ParkSmart, Split Unit, Controller and Harness Changes

83-150

Freightliner
Service Bulletin

Fig. 1, Circuit Board Wiring

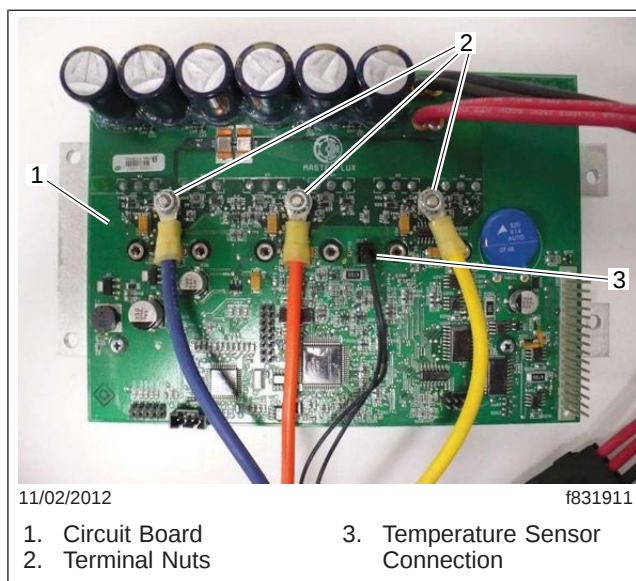
A design change has been made to the ParkSmart internal controller circuit board to protect against high voltage damage. The new controller is installed in all vehicles manufactured from June 21, 2012.

If the ParkSmart unit part number is A22-69027-000 and it was built before March 6, 2012, a new controller-to-compressor harness is required to adapt to the spade-type compressor terminals. See [Table 1](#) for the required parts for different controller and harness configurations.

- 2.1 Connect the three phase-wires to the new circuit board terminals as shown in [Fig. 1](#). Install the blue wire on the left terminal, the orange wire on the middle terminal, and the yellow wire on the right terminal. Tighten the nuts 10 lbf-in (113 N-cm).
